Project Title :	DFE River Academy	Project Ref :	FS0949
Main Contractor :	Bowmer & Kirkland

Lighting Calculations

External Lighting

Document Reference : FS0949-DBS-ZZ-ZZ-CA-E-0002

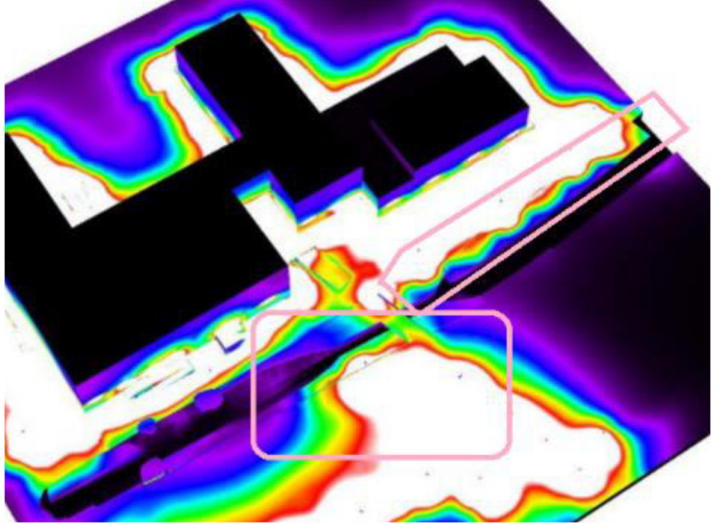
2	Date Comment Received:	01.09.23
	Comment Transmission Method:	E-mail (Andy Taylor BNK)
	Building Reference:	1038
	Comment Reference:	RE: River Academy Ecology condition report amends – Condition 38
	Client/Consultant Comment:	1. Area around service yard noted as omitted from contour drawing (page 9 of the external lighting technical submittal report). I wouldn't say it was omitted, rather the corner was "cut off" from the report. As per the lux plot drawing this area has been modelled. @Vaidas Perednis could the report be updated to include this area? @Kiri Shuttleworth thoughts on just re-issuing the lux plot drawing and lighting calculation report? 2. Request noted asking for lighting lux/contours overlaid with location of biodiversity enhancements (our report as submitted in response to condition 39 89826.550972_REP_River-Academy-Reading_BES_2023-06-26 attached). @Vaidas Perednis can you look into providing this bird and bat boxes to be located as per page 4 of that report? 3. Further questions from the council's ecologist remain regarding lux levels in the ditch area. 5 lux again mentioned in the memo as being too high.

4. @Vaidas Perednis I believe the contour map is in the scenario of all lights on. Can this be clarified in the report with a second contour map showing the situation with those 7 lights switched off between the hours of 10pm and 7am?
	DBS Response:	(15.09.2023) <i>This document is to be read in conjunction with external lighting technical submission reference: FS0949-DBS-ZZ-ZZ-TS-E-0004.</i> - Report updated with service yard corner could be seen. - Nesting box locations have been added to lux plot drawing Ref: 0002223324-EX-R4-dwg-A0 - Additional 4No. Luminaires near ditch added to group of luminaires switching off between the hours of 22:00-07:00. As per Cathy Holwill (RBC Ecology Consultations) mark up (See below)  - Two contour maps added to FS0949-DBS-ZZ-ZZ-TS-E-0004 showing lux levels when all lights on and other when 11No. luminaires around ditch switched off between the hours of 22:00-7:00
